NORTHERN STATES POWER COMPANY
MONTICELLO NUCLEAR GENERATING PLANT

REQUEST FOR AMENDMENT TO
OPERATING LICENSE NO. DPR-22

(License Amendment Request Dated July 29, 1977)

PROPOSED CHANGES TO TECHNICAL SPECIFICATIONS
APPENDIX A OF PROVISIONAL OPERATING
LICENSE NO. DPR-22

Figure 1 Scram Reactivity and Control Rod Drive Specifications,
Monticello Cycle 6

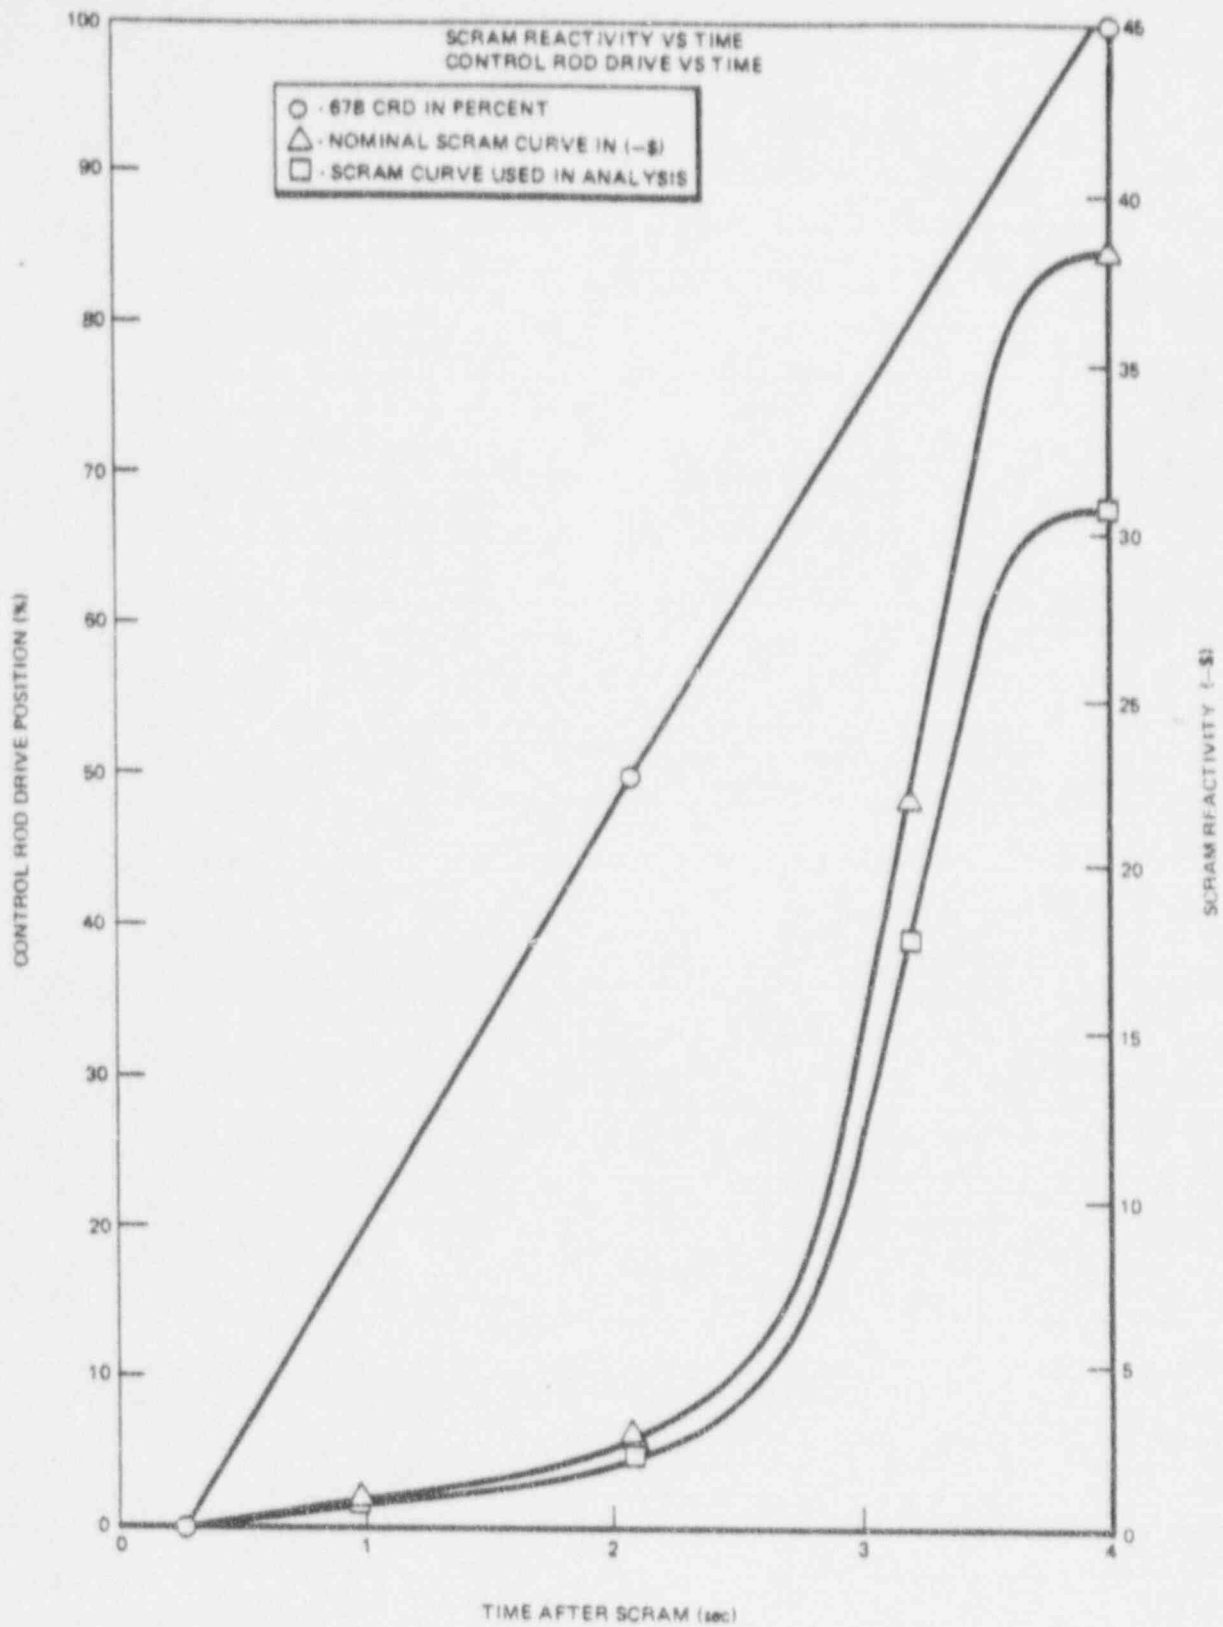
The MCPR operating limit is derived by adding to the MCPR safety limit the maximum delta CPR of the limiting abnormal operational transient. The reactor transients and the thermal hydraulic responses were analyzed as described in the topical report, "GE/BWR Generic Reload Licensing Application for 8x8 Fuel, Revision 1, Supplement 4, April 1976, NEDO-20360". It was found that at the end of the next cycle the turbine trip without bypass event and the generator load rejection without bypass event are equally limiting, having a delta CPR of 0.40 for 8x8 fuel. (All 7x7 fuel will be removed from the core during the next refueling outage.) The MCPR safety limit of 1.06 is not changed, placing the new MCPR operating limit at 1.46. The input and output for the limiting transient calculations are presented in the attached Tables 1, 2 and 3 and Figures 1, 2 and 3.

FIGURE 3 MONTICELLO
TURBINE TRIP WITHOUT BYPASS, TRIP SCRAM

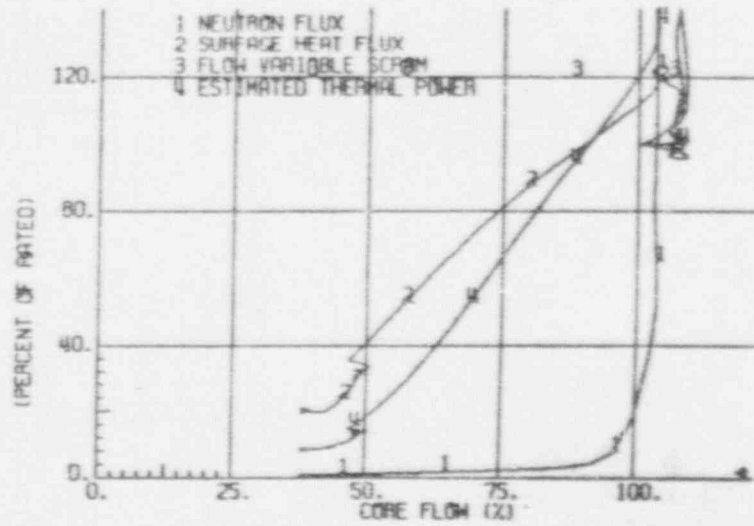
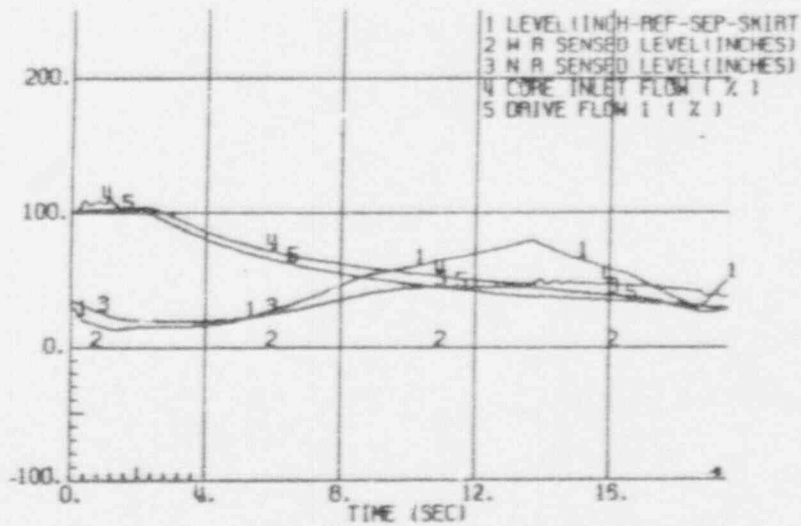
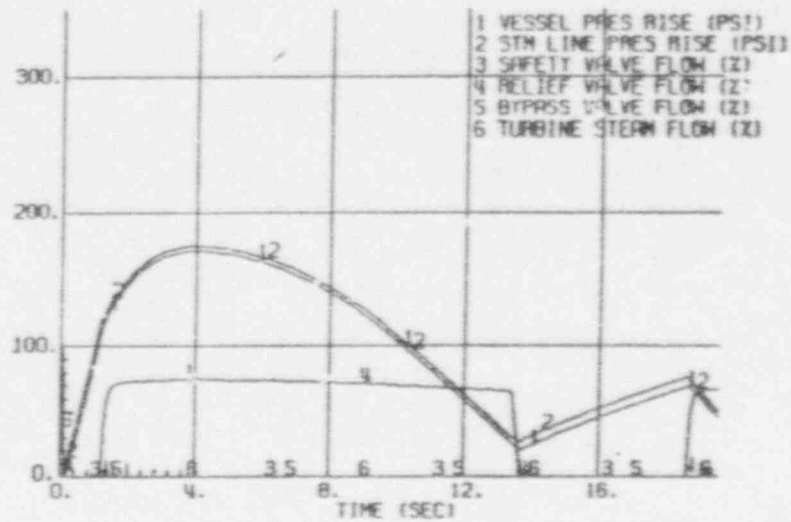
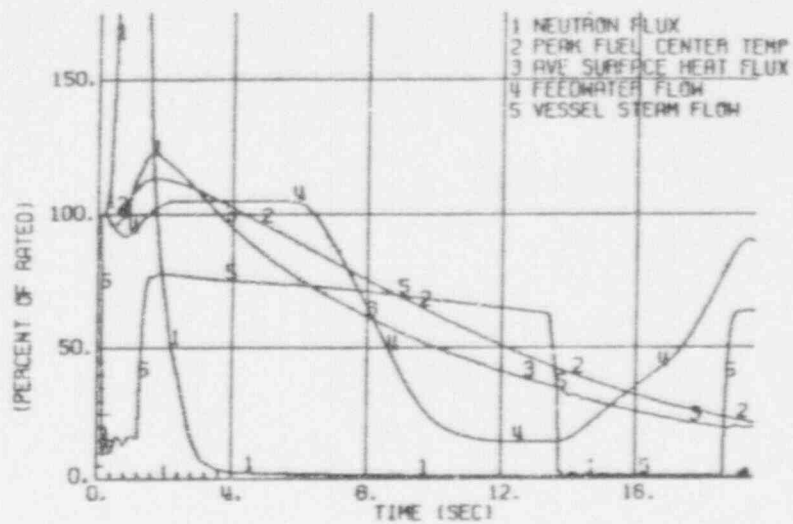
An analysis for conditions expected at the end of the next cycle was recently done using the same model as in the past except that GETAB replaced the Henschel-Levy correlation. The results of a turbine trip without bypass showed a delta CPR for the pump trip case 0.08 smaller than the case without the trip. In evaluating this unexpected situation, it was discovered that in the past the pump trip was modeled to occur too rapidly. The appropriate corrections, referenced to measured plant data, were incorporated into the model. The modified transient model was used for analysis of the next cycle. An adjustment of 0.08 to the MCPR operating limit is bounding for the duration of the present cycle. A re-analysis of the transient shows that the recirculation pump trip occurs too late to have any effect in determining thermal limits. Turbine and generator trips will continue to be modeled to include the pump trip to best represent the existing equipment.
